RE: Forest Service Comments of the Recompiled PAP,
Beaver Creek Coal Company, Trail Mountain #9 Mine,
ACT/015/009, Folder #2, Emery County, Utah

RE: Amendment to Conduct Second Mining East of Escarpment in
Cottonwood Canyon, Beaver Creek Coal Company, Trail Mountain
#9 Mine, ACT/015/009-88A, Emery County, Utah

We have received from your office a copy of Beaver Creek Coal Company's PAP Amendment, Second Mining East of Escarpment, Trail Mountain #9 Mine, ACT/-015/009-88A. We were to review and provide any comments or recommendations to your office concerning this proposal. Our response is to confirm telephone conversations between Stephen Falk in our Price office with Pamela Grubaugh-Littig of your staff.

SOUTH MAIN PILLAR EXTRACTION SEQUENCE

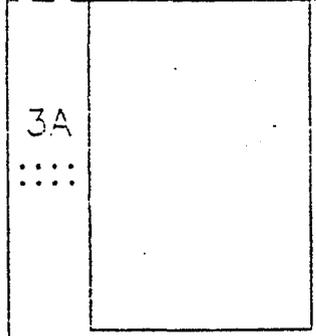
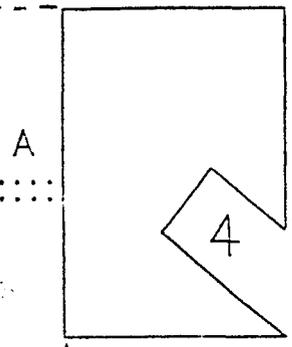
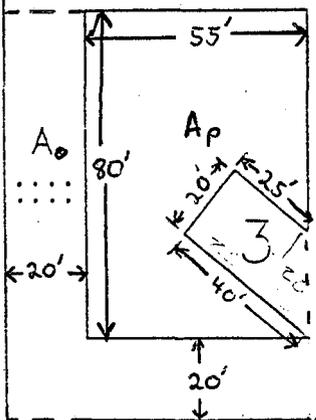
We have used another method from Obert and Duvall to substantiate Beaver Creek's conclusions. We looked at the exact partial pillar extraction sequence that Beaver Creek proposed to use in the South Mains. South Mains has 5 entries, with 4 pillars of 55x80-foot size. Beaver Creek plans to turn 30-foot cuts on angle into each pillar. With a standard 20-foot-wide mining cut, we figure that 4,550 ft.³ of coal would be removed from each pillar based on an average 7-foot seam and mining height. The 55x80-foot pillar would have 26,250 ft.³ left remaining after the 30-foot angled cut (see enclosed pillar extraction map). This scenario would give a 60 percent recovery in the mains with no accounting for panel barrier pillars. A design equation from Obert and Duvall is:

This assumption is accepted by industry and experts, though exact vertical stresses are very complex due to changes in geologic structures. For simplicity, the density of the overburden is 144 lbs./ft.³, which is a reasonable average of the various rock formations above. Hence, the vertical stress used in calculation is a direct relationship to the amount of overburden. The overburden in the area of proposed partial pillar extraction ranges from 1,300 feet to 1,000 feet. With the 60 percent recovery rate, the stress on the pillar will range from 3,250 psi to 2,500 psi.

Using the mean compressive strength and the range or overburden stresses, we calculate a factor of safety between 1.1 and 1.5.

This rock mechanics evaluation determines only failure of the pillar. It is assumed that if pillars fail, subsidence effects will manifest themselves to the surface in the form of cracks or ground lowering. This may or may not happen. However, we feel with the calculated stress scenario and the fact that large barrier pillars will remain in place on both sides of South Mains that the strata will hold and no subsidence will occur. One must also realize that a large pillar area in the 1st West panel was completely pulled before the permit stipulation for areas of no second mining was issued. This area was under the escarpment and no detectable subsidence failure has been observed. We therefore give our opinion that Beaver Creek's proposal will not cause failure of the escarpment.
